MESHESAT-1357, stream a1mech, 29 Sep 2026. Case frame: X east, Y toward the hinge (back) wall, Z up from the base floor, lid closed. mm. Prototype design, AI review: nothing built, bought or fitted; analytical success is not physical verification.

MeshSat field kit V2, Option A(i) lid pack: sheet A1-2 sections: the module under the ceiling over the face, at the worst room

MeshSat field kit V2, Option A(i) lid pack: sheet A1-3 the arrangements that fit, and the owner decision

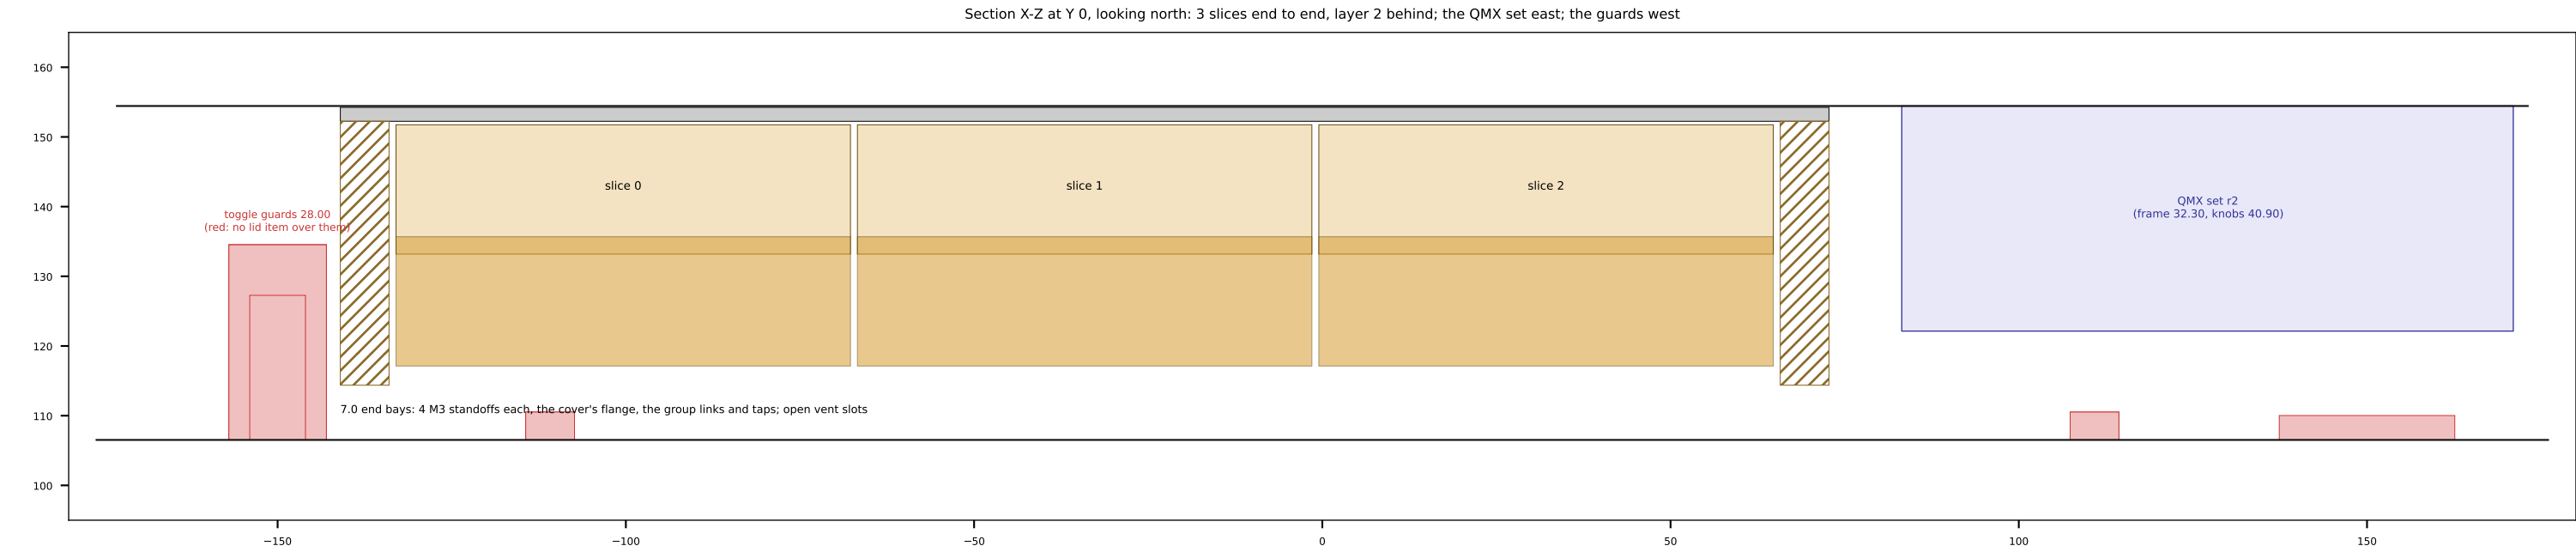
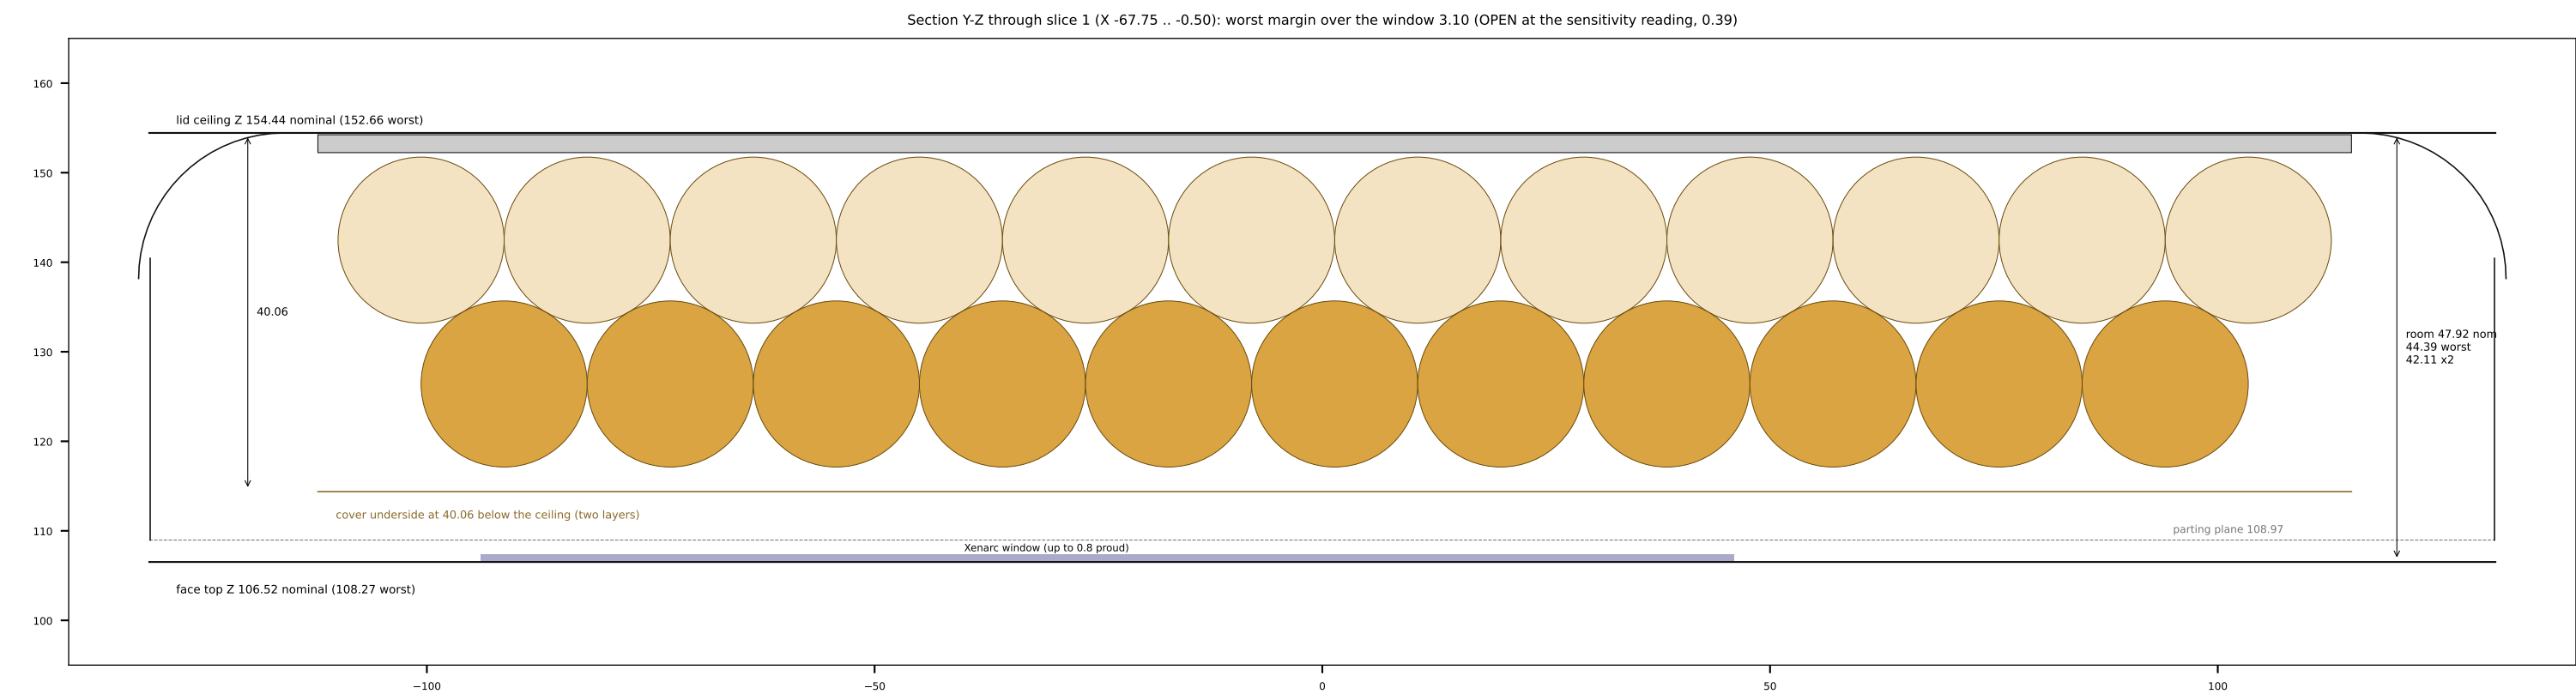
ROOM face top to ceiling: 47.92 nominal, 44.39 worst,
42.11 sensitivity (frame seat.out, r2 record B)

```
TIGTEST ROWS (worst, x2; min 1.0)
two layers over the Xenarc window 0.80: 3.10, 0.39 OPEN
two layers over the LED bar 1.50: 2.40, -0.31 OPEN
two layers over the e-paper lens: 3.85, 1.14 MET
one layer over the XFRAME screws: 15.96, 13.25 MET
layer 2 refused over XFRAME 1 and 3 (4.00): -0.10 worst
```

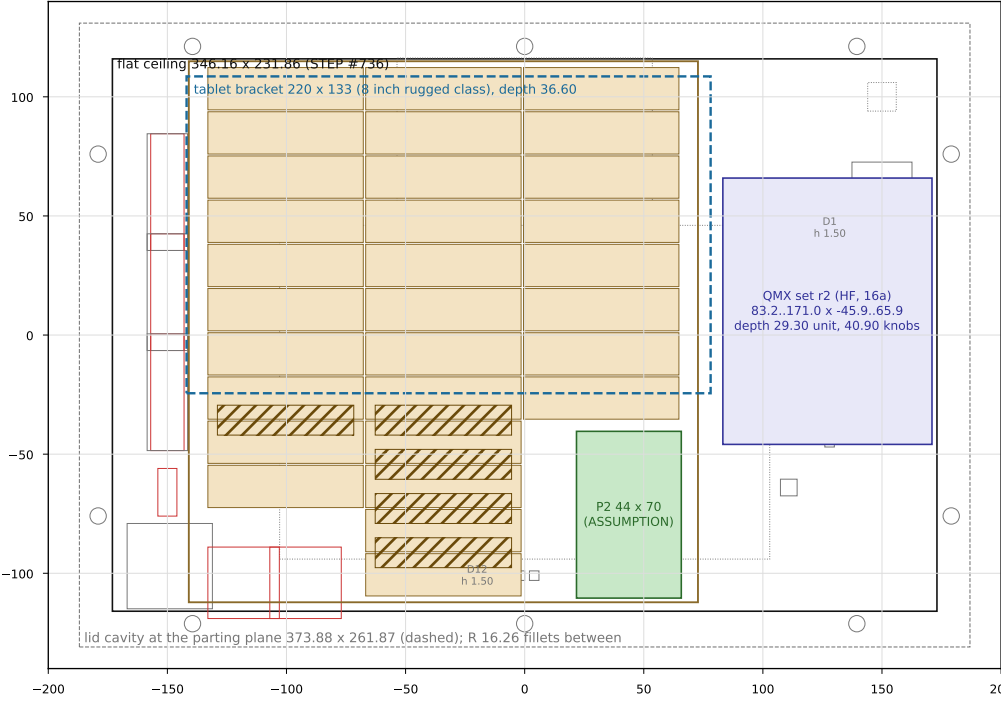
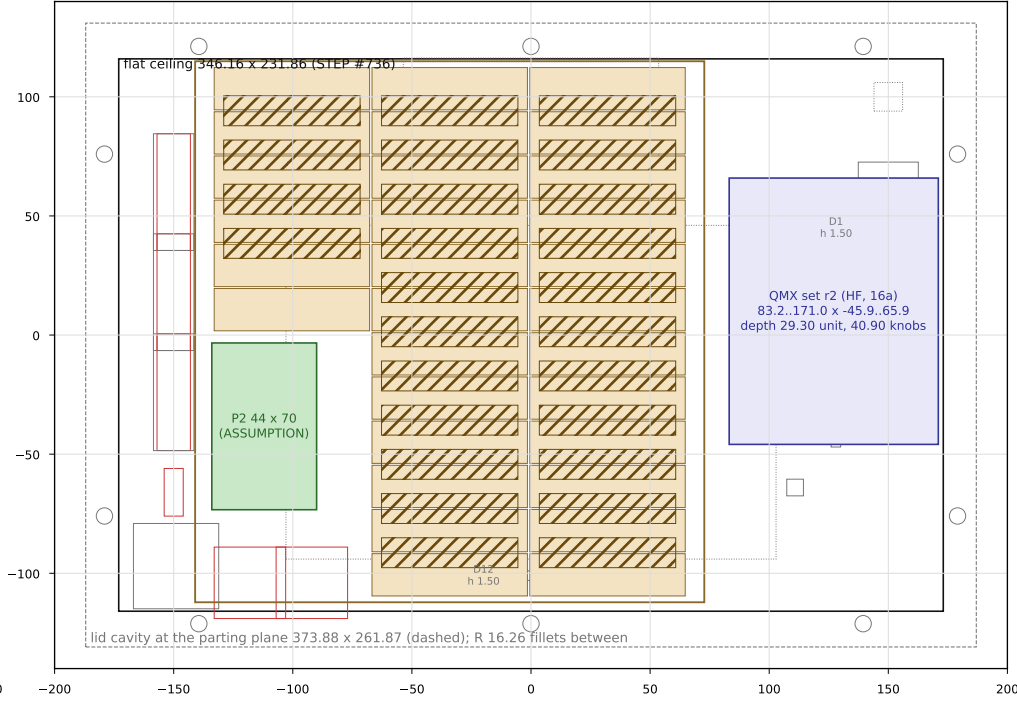
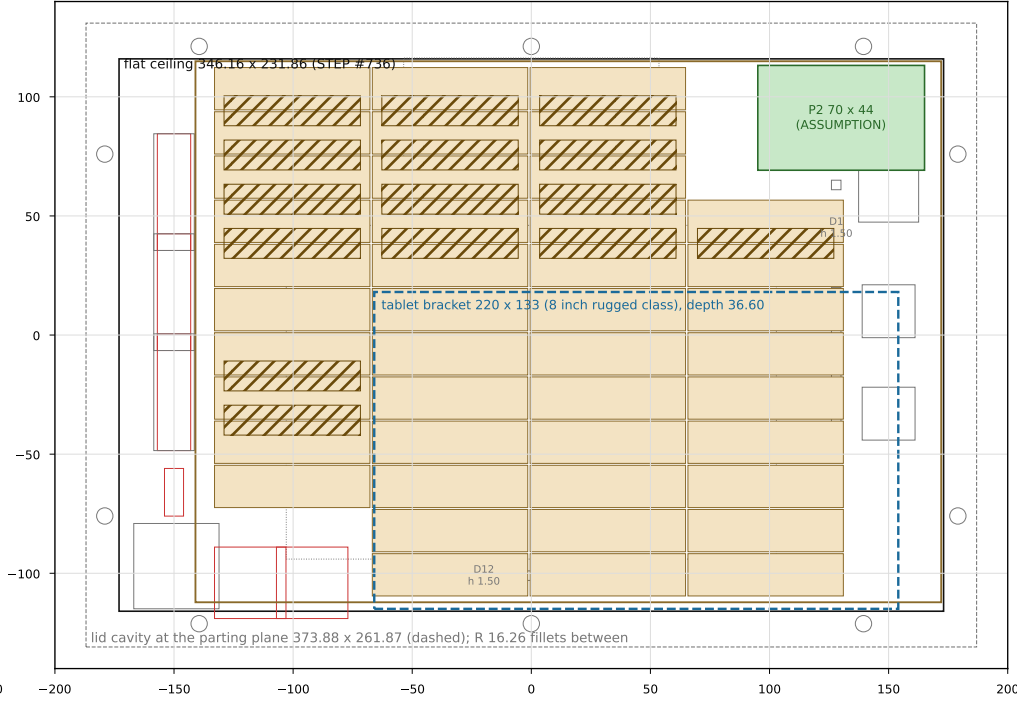
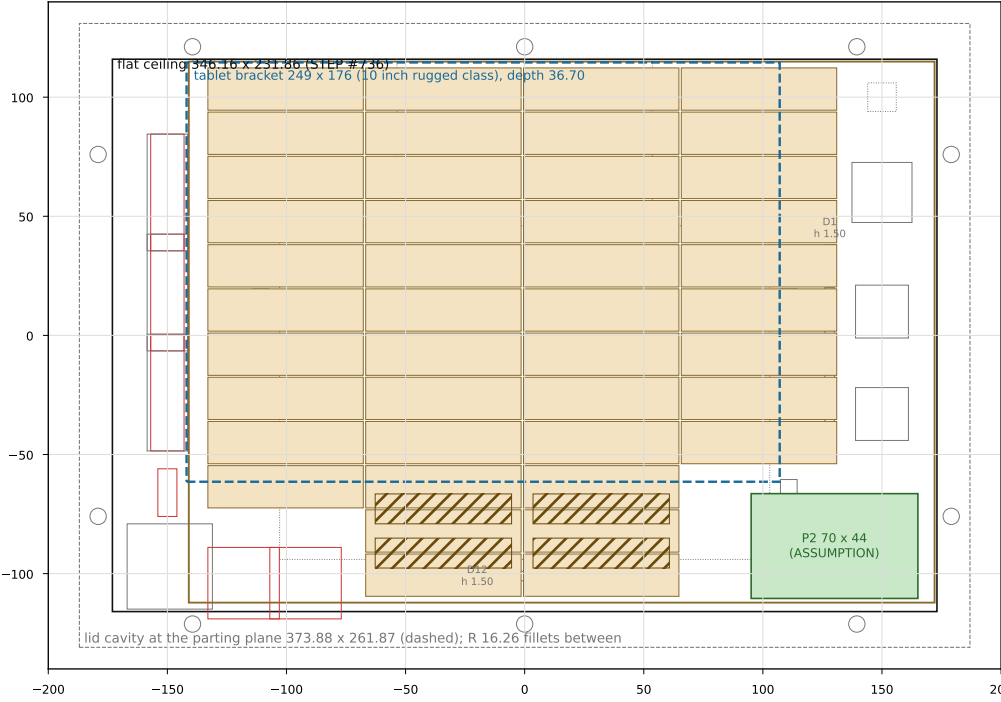
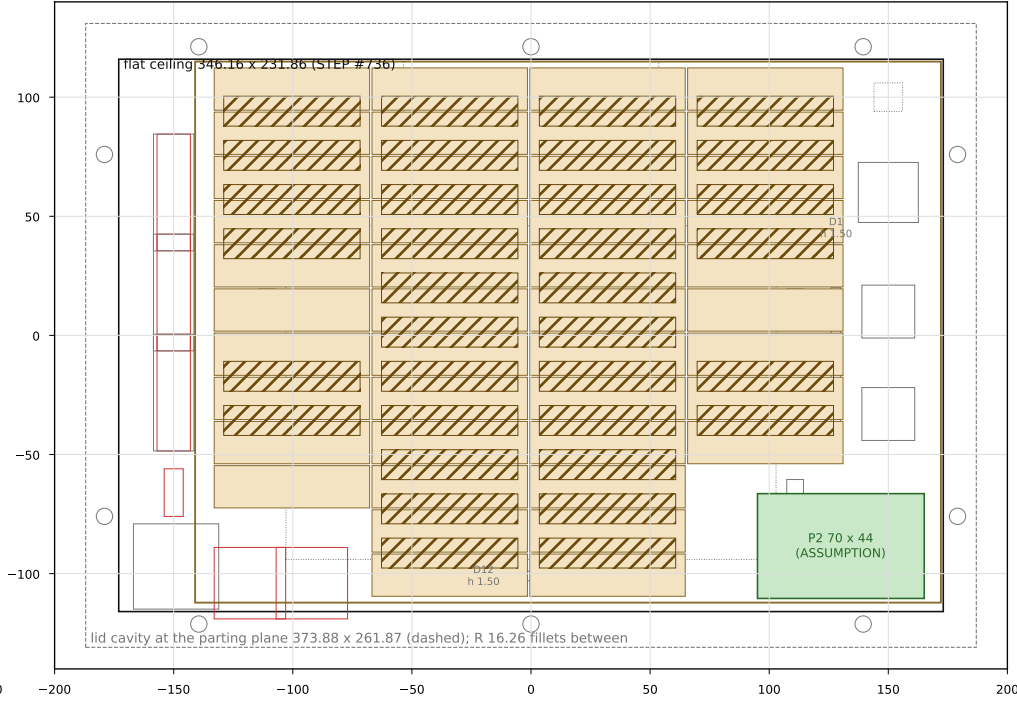
48 cells (4S12P) in the lid with BOTH the QMX HF set (16a) and the tablet bracket (16d): DOES NOT FIT. At the worst room the lid holds 35 places with both, 4S8P; the total 4S14P is under section 9c's 4S15P floor.

What fits 4S12P (each with every row of sheet A1-1 at or above its minimum at the worst):
1. HF kept, tablet bracket out of the lid: 56 places (4S14P); the tablet goes out of the case.
2. 8 inch tablet kept, HF (QMX) out of the lid: 58 places (4S14P); HF inside (16a) is lost: the base has no volume for the QMX set (section 8)
3. Both kept, lid pack 4S8P: not Option A(i); M1 not met on section 9's model

Session's recommendation (engineering view only): option 1, which keeps a radio bearer and gives 8 spare places; the tablet works from outside the case on the kit's WiFi and USB-C outlet.

MeshSat field kit V2, Option A(i) lid pack: sheet A1-5 mass and open-lid stability

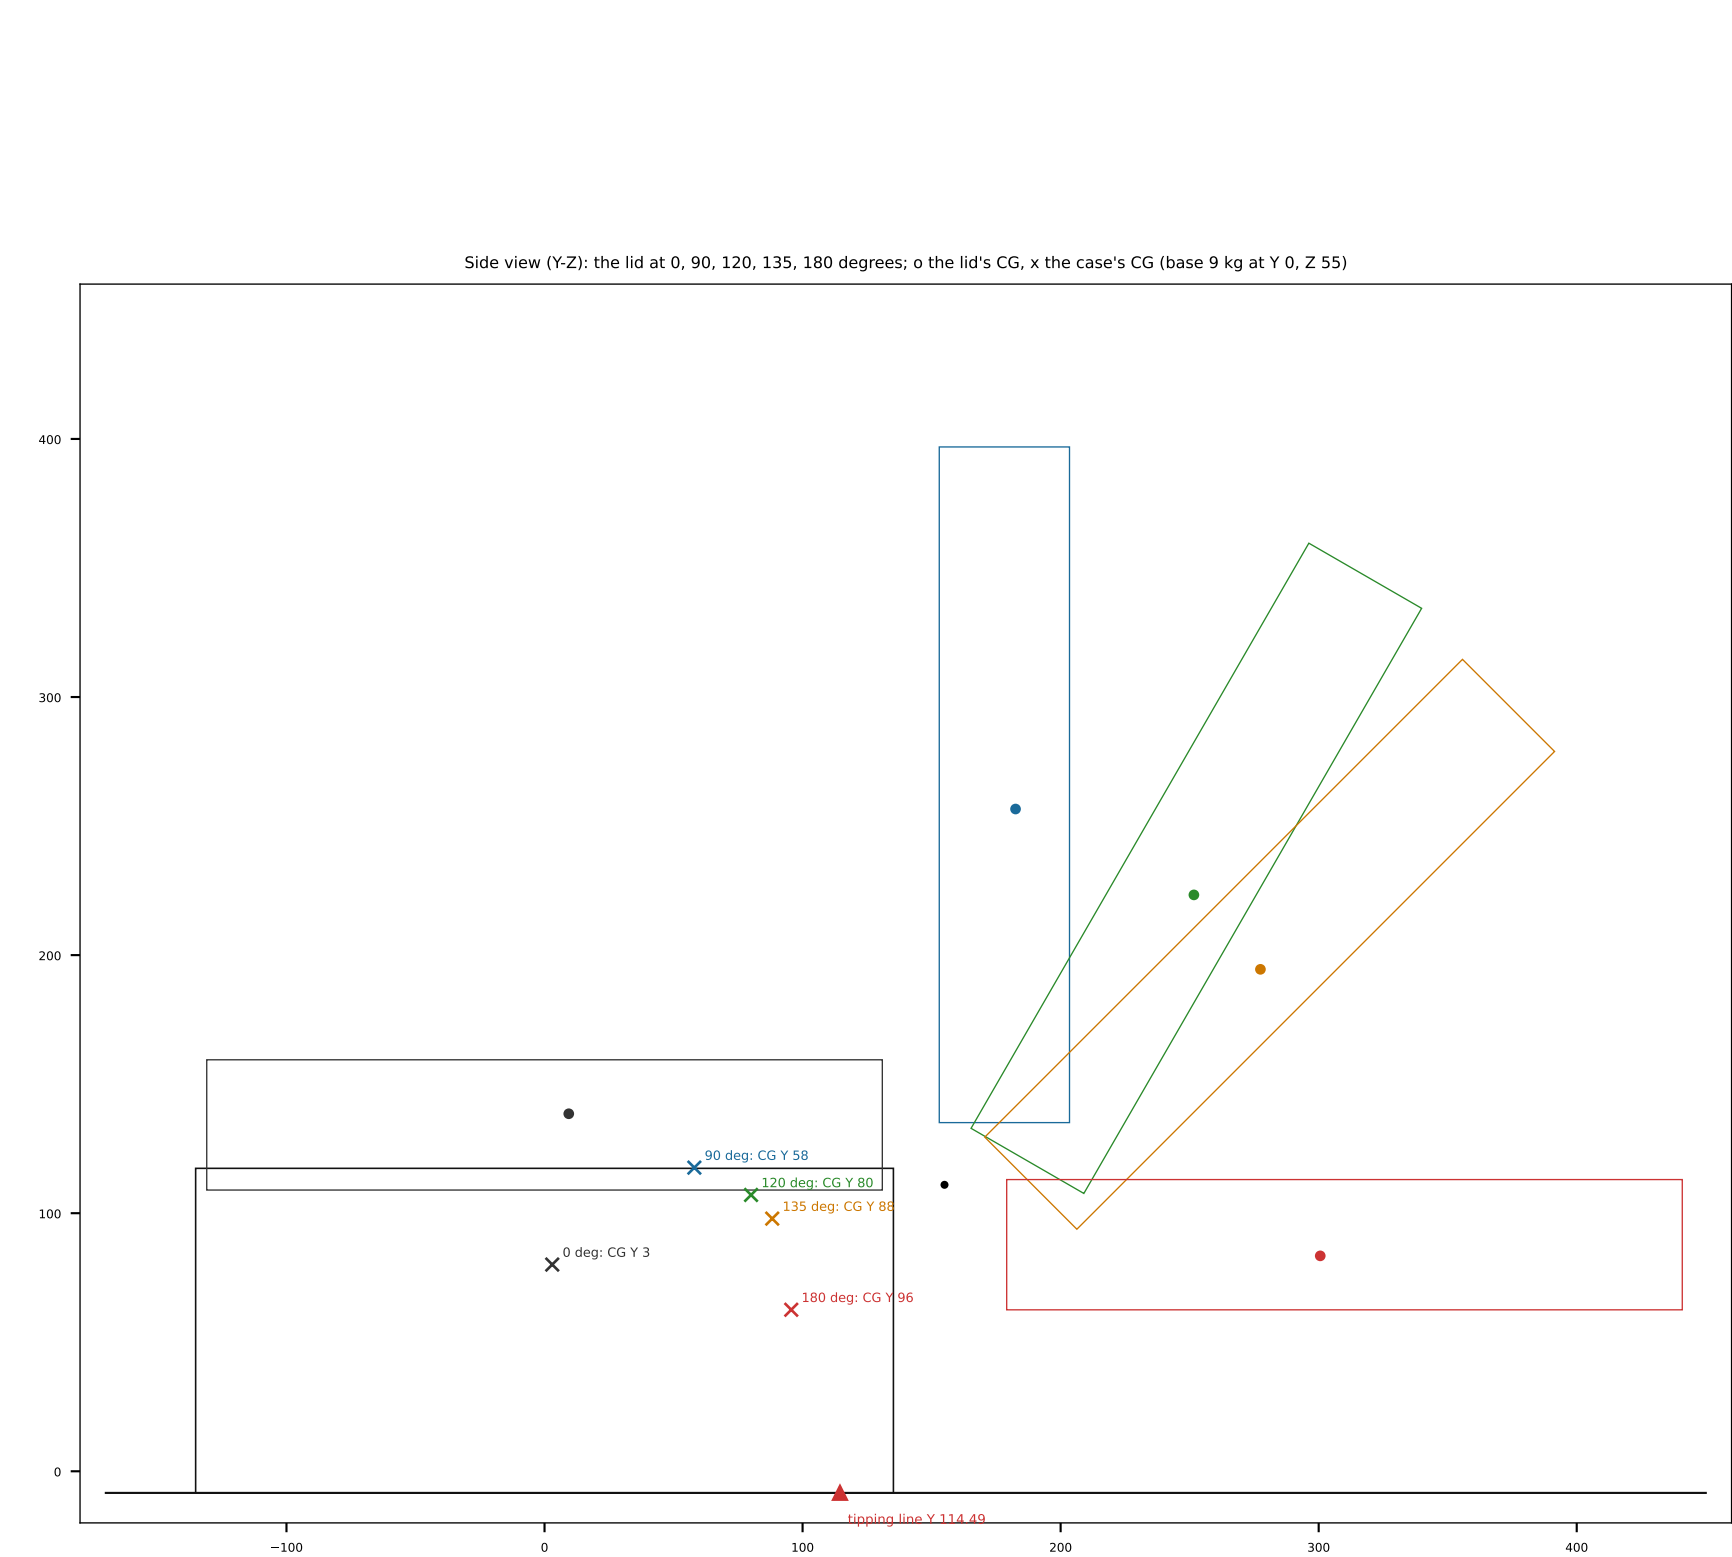
lid open	B	A
90	14.9	17.1
100	11.6	14.0
110	8.4	11.1
120	5.4	8.4
135	1.3	4.9
150	-2.2	2.2 (tips on level ground)
180	-5.0	1.7 (tips on level ground)

VERDICT: stands on level ground to 120 degrees of opening in every swept case; a light base tips from 135. FIX (SESSION, reversible): a lid stay stopping the lid at 100 degrees (webbing strap between two bonded anchors, lid back wall and plate back band; no hole; about EUR 10, ESTIMATE). With it the open case stands on a slope of about 10 degrees at the worst (lid_pack a1.out section 4). The stop angle, the hinge axis and the case's CG are read on the mock-up (T-A1-3); Peli states no load for its hinges (T-A1-4).
